580	Case ref. no:	Y19/0415/FH	Case Officer	Katy Claw
Property Address:		Verneys High Street Elham Canterbury Kent CT4 6TD		
Proposals:		Listed Building Consent for the removal of an existing rear window to be replaced with French doors and replacement of 3x windows on rear elevation with timber slimline glazing.		
Application Type		LBC		
Agent:		Mark Horner Architecture		
General Comments Operative Conditions?				
Listing / C/A?		Grade II, Conservation area		
Date Consult Received:		27/09/19		
Date Comments Sent:

2-Development Proposals:

'Verneys' High Street, Elham, Kent

Client:	Will Power
Title:	Rear elevation patio door elevation and details
Drawn:	Les Andrews 1.06/2019
Scale:	Full size and 1:20 @ A3

NEW PATIO DOORS
EXTERNAL
ELEVATION

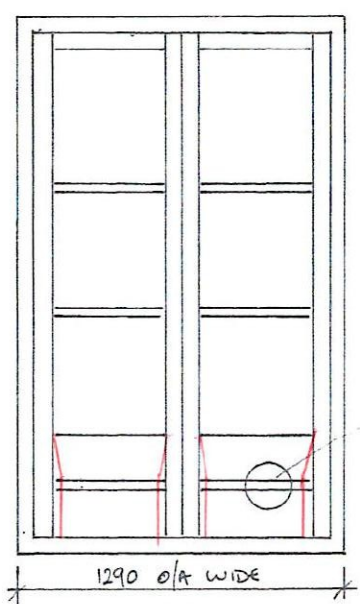
The principle of converting the casement window back to a door is ok but, previously no large-scale details were provided. The application now includes door details which are generally ok. I

would suggest some minor modifications to the details, which will improve the design:

- Ideally the styles should be gunstock pattern (with a wider section at the bottom rail) this produces a stronger door without needing thick styles at the upper glazed level.
- The glazing bars are still rather oversized and should be reduced down from 25mm to 19mm.
- Ideally the frames should have a cock bead all around the door opening - this is traditional detailing and makes the door appear more 'finished
- There should be a bead moulding all along the leading edge of the doors – this enables the meeting styles to appear to be the same width
- The drip molding along the head frame of the doors is not a traditional detail and should be omitted

I enclose a copy of their French Door details with annotations to show recommended minor adjustments to the design. Ideally the application should be amended to incorporate these points

Revert to Applicant advising that the principal of what is being proposed is okay but they need to amend the French door design as suggested and slim down the window glazing bars

JAMB + HEAD DETAIL PLUS
SIDE STILES + TOP RAIL DETAIL

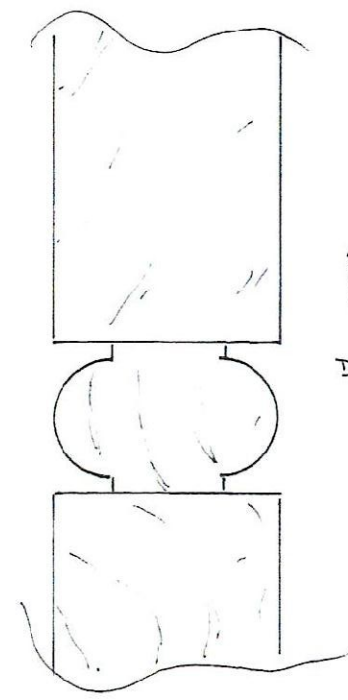
can this be reduced to
14mm rather than 25mm

14mm

Windows too

more traditional frame
moulding

MEETING STILE DETAILS

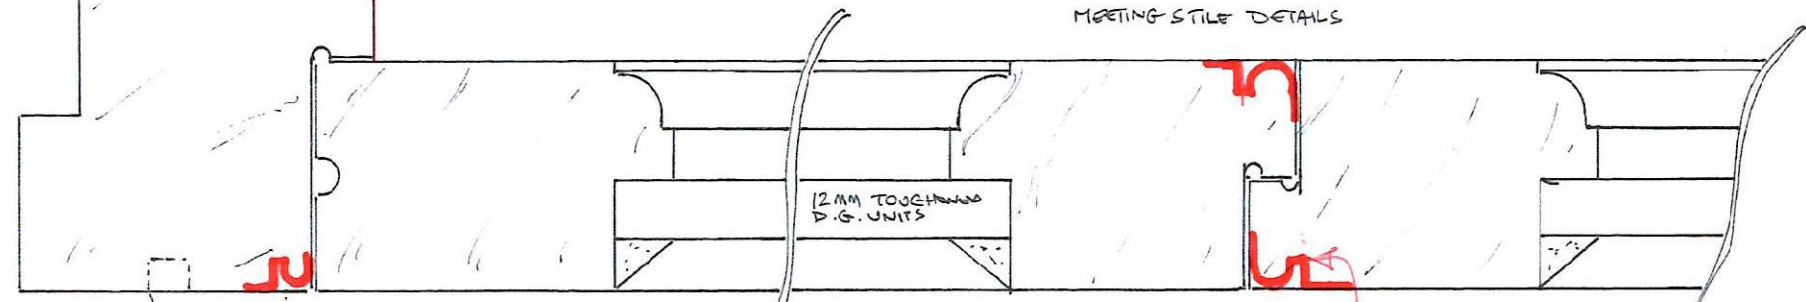
6mm cockbead recommended

Suggest meeting
style beading. This
equalizes stile widths

~~Drip moulding to
frame head only~~

omit this detail
